Model: OR-C1 Fax Option Type 3352		Date: 02-Dec-11	No.: RD596001
Subject: Service Manual Correction		Prepared by: T. Nihei	
From: 2nd Tech Service Sect., MFP/P Tech Service Dept.			
Classification:	<input type="checkbox"/> Troubleshooting <input type="checkbox"/> Mechanical <input type="checkbox"/> Paper path <input type="checkbox"/> Product Safety	<input type="checkbox"/> Part information <input type="checkbox"/> Electrical <input type="checkbox"/> Transmit/receive <input type="checkbox"/> Other (     )	<input type="checkbox"/> Action required <input checked="" type="checkbox"/> Service manual revision <input type="checkbox"/> Retrofit information <input type="checkbox"/> Tier 2

## Service Manual Correction

Model:OR-C1 Fax Option Type 3352		Date: 27-Jan-12	No.: RD596002
Subject: Service Manual Correction (RCN only -Certification decal)		Prepared by: T. Nihei	
From: 2nd Tech Service Sect., MFP/P Tech Service Dept.			
Classification:	<input type="checkbox"/> Troubleshooting <input type="checkbox"/> Mechanical <input type="checkbox"/> Paper path <input type="checkbox"/> Product Safety	<input type="checkbox"/> Part information <input type="checkbox"/> Electrical <input type="checkbo

- G3 Interface Unit (D596 -11/-12)

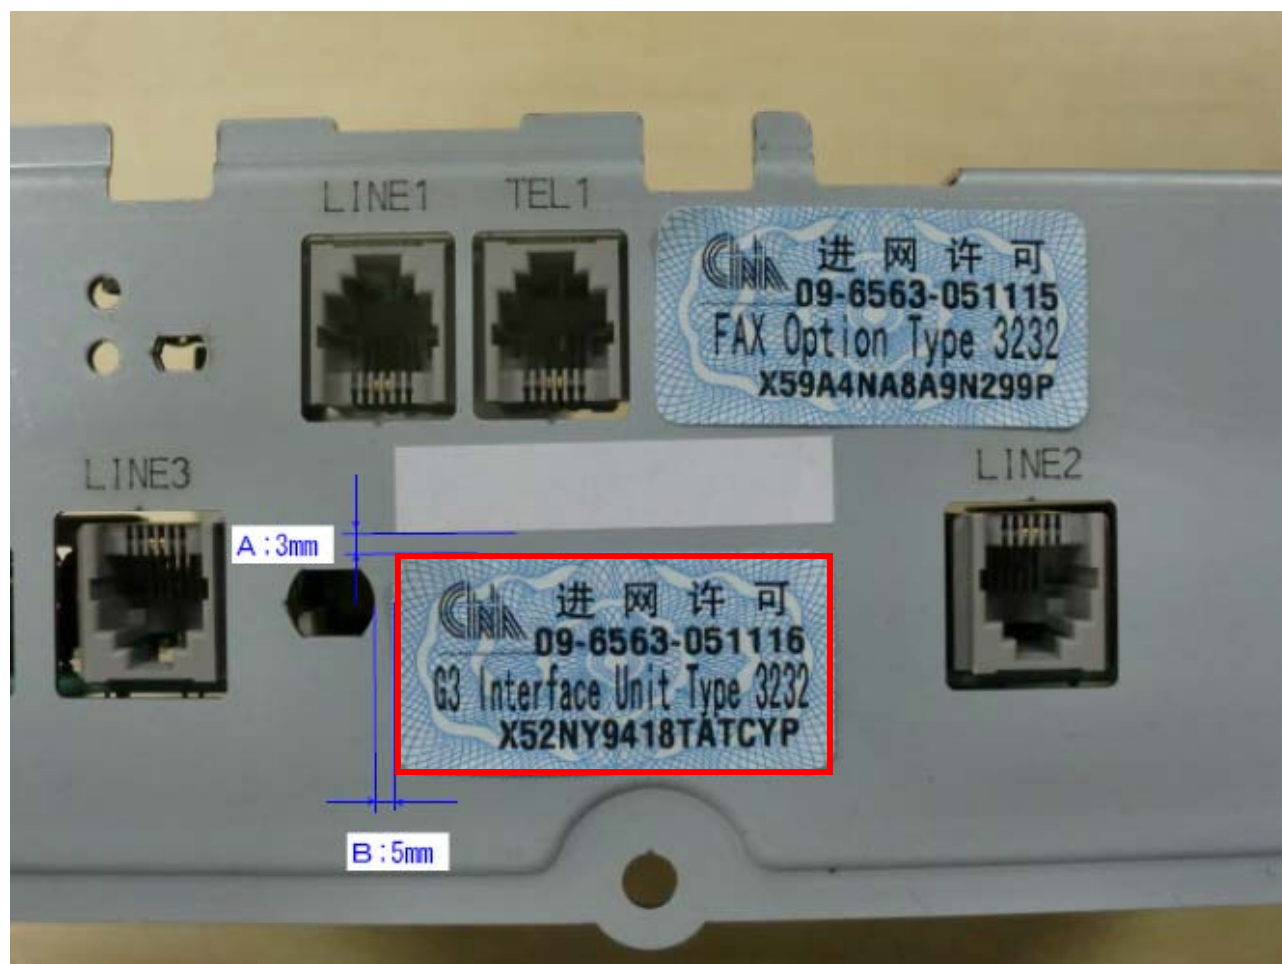
If a serial number decal is not attached to the fax unit, attach it to the unit's faceplate.

**Attach the decal packaged with the G3 Interface Unit to the area shown in red below. This decal shows that the fax is compliant with Chinese communication standards.**

d596i100a

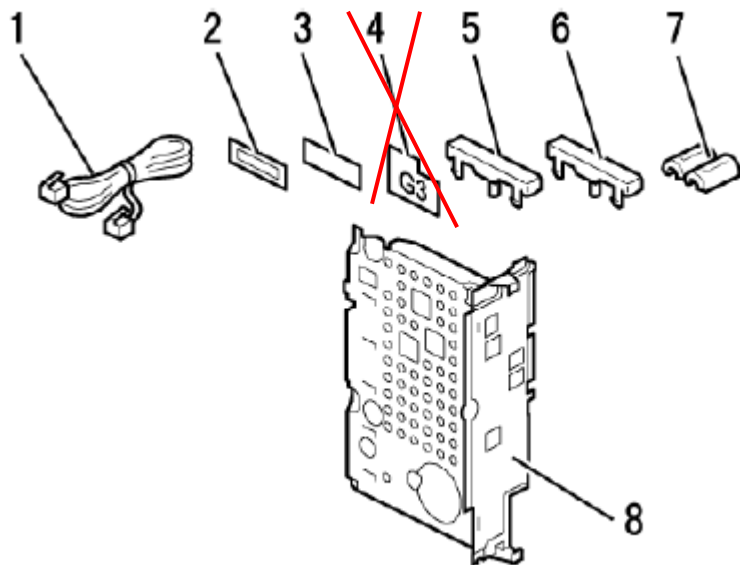
**Note: These corrections were made because the G3 decal was deleted in September 2011.**

No.	Description	Q'ty
1.	Telephone Cable (NA only)	1
2.	Serial Number Label	1
3.	FCC Label (NA only)	1
<del>4.</del>	<del>G3 Decal</del>	<del>1</del>
5.	Fax Keytops	2
6.	Copy Keytops	2
7.	Ferrite Core	1
8.	Fax Unit	1

d596i105

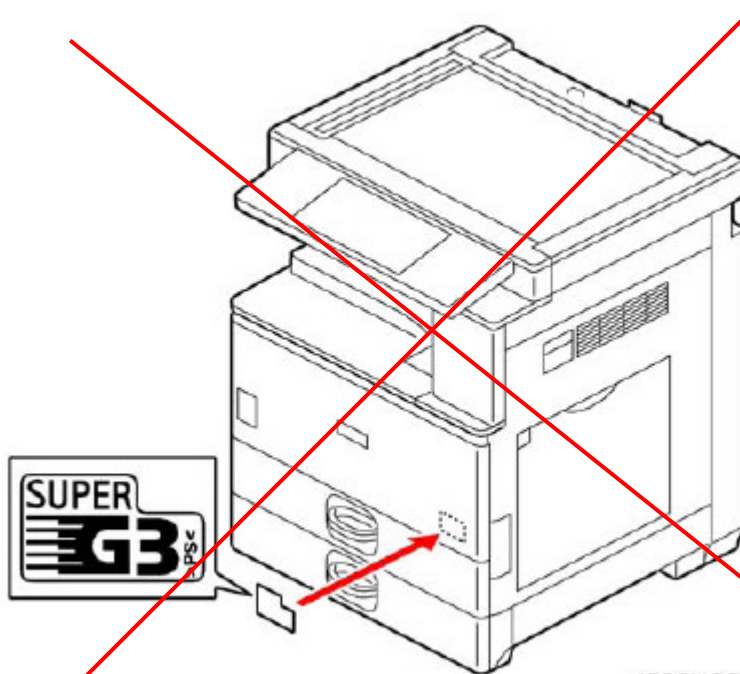
~~19. Attach the G3 decal to the front of the machine.~~
